APPEAL SUMMARY

Appeal ID: 18782	Project Address: 111 SW Naito Pkwy
Hearing Date: 12/19/18	Appellant Name: Sara Ruzomberka
Case No.: B-005	Appellant Phone: 503-896-5360
Appeal Type: Building	Plans Examiner/Inspector: Gail Knoll; Megan Sita Walker
Project Type: commercial	Stories: 4e Occupancy: B Construction Type: III-B
Building/Business Name:	Fire Sprinklers: Yes - under canopy
Appeal Involves: Erection of a new structure	LUR or Permit Application No.: 18-255157-LU
Plan Submitted Option: pdf [File 1]	Proposed use: Screening and Protection of trash/recycling and mechanical equipment.

Re: Land Use Review LU 18-255157 HR – Smith Block Enclosures, Mechanical Unit, and Awnings

SITE PLAN / EGRESS DIAGRAM

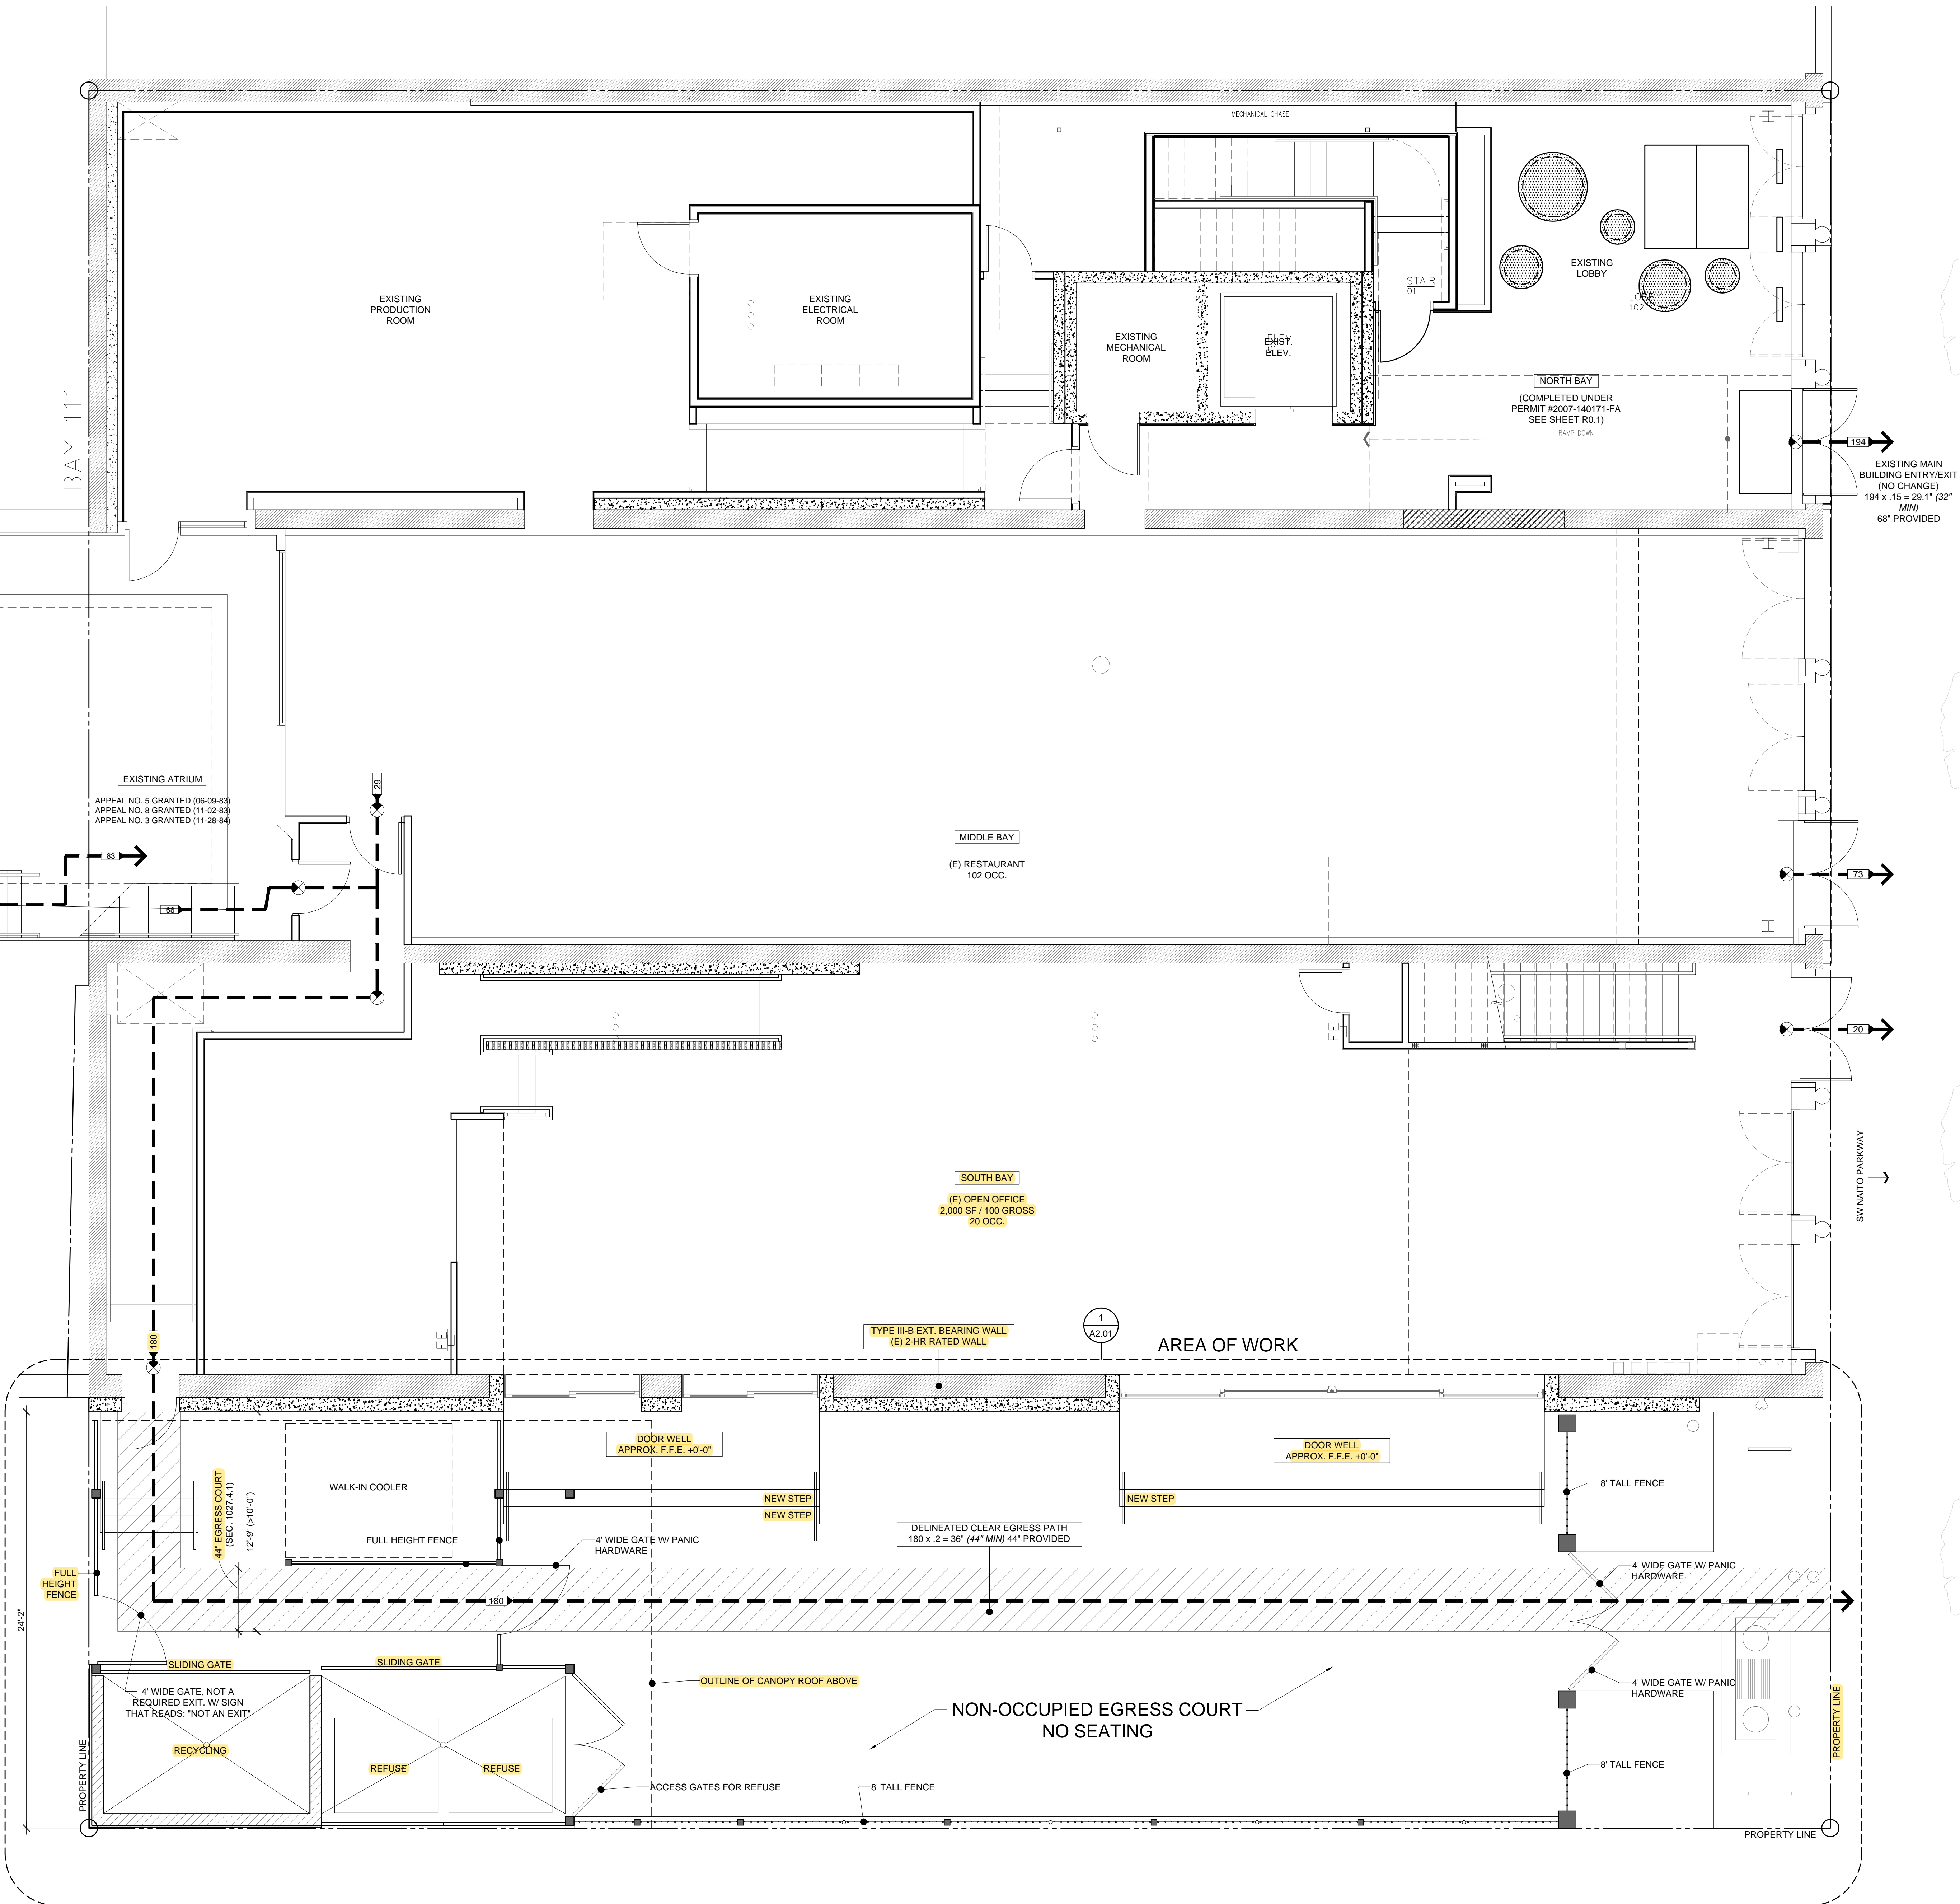
In our Preliminary Life Safety Review meeting on December 11, 2018, Gail Knoll stated the proposed canopy covering the trash area conflicts with the definition of egress court. Gail cited OSSC section 1206 for yards or courts, and OSSC 202 defining yards or courts as "an open uncovered spaced, unobstructed to the sky".

While the definition of courts and yards, states “unobstructed to the sky”, OSSC 1027.4 specifically states “...The minimum width of egress courts shall be unobstructed to a height of 7 feet.” We would like to argue that because there is a specific height listed in the section for egress courts that assumes there could be obstructions above 7 feet in egress courts, this would overrule the minor definitions for courts and yards and allow a cover for the space (above 7 feet).

OSSC 1027.4 states that egress courts may serve as a portion of the exit discharge in the means egress system. OSSC 1027 describes the requirements for an Exit Discharge. The area below the canopy serves as an Exit Discharge and meets the requirements. Section 1027.3 states Exit Discharge components shall be sufficiently open to the exterior so as to minimize the accumulation of smoke and toxic gasses. The proposed canopy is sufficiently open to the exterior.

In addition, OSSC 1019 Egress Balconies provides a similar construction situation to the one proposed with clear statements and compliances which are met by the proposed cover. In this section it states that balconies used for egress purposes shall conform to the same requirements as corridors for width, headroom, dead ends and projections. Exterior egress balconies shall be separated from the interior of the building by walls and opening protectives as required for corridors. The long side of an egress balcony shall be at least 50 percent open, and the open area above the guards shall be so distributed as the minimize the accumulation of smoke or toxic gas. Exterior egress balconies shall have a minimum FSD of 10' from exterior edge of the egress balcony to adjacent lot lines. While we understand the area under our proposed canopy is not an actually balcony, it fits the definition of Egress Balcony. From the exit door on the building to the east gate of the canopy, you are along a length of 2-hr rated exterior wall with no openings so the path is protected from fire. Taking it more literally, we could revise the design of the canopy walls to be 50% perforated meeting the 50% open requirement. Technically, it is 10' from the south lot line to the 44" wide egress route. OSSC 1016.2.1 Exterior Egress Balcony Increase states, Exit access travel distances specified in Table 1016.2 shall be increased up to an additional 100 feet provided the last portion of the exit access leading to the exit occurs on an exterior egress balcony constructed in accordance with Section 1019. The length of the balcony shall not be less than the amount of the increase taken. This definition states the code recognizes that egress balconies that are protected per 1019, are safe component of exit access. We would argue that because the proposed canopy fits the requirements, it should be allowed to be part of the exit access.

1. Exit discharge through trash enclosure: Denied. Proposal does not provide equivalent Life Safety protection.
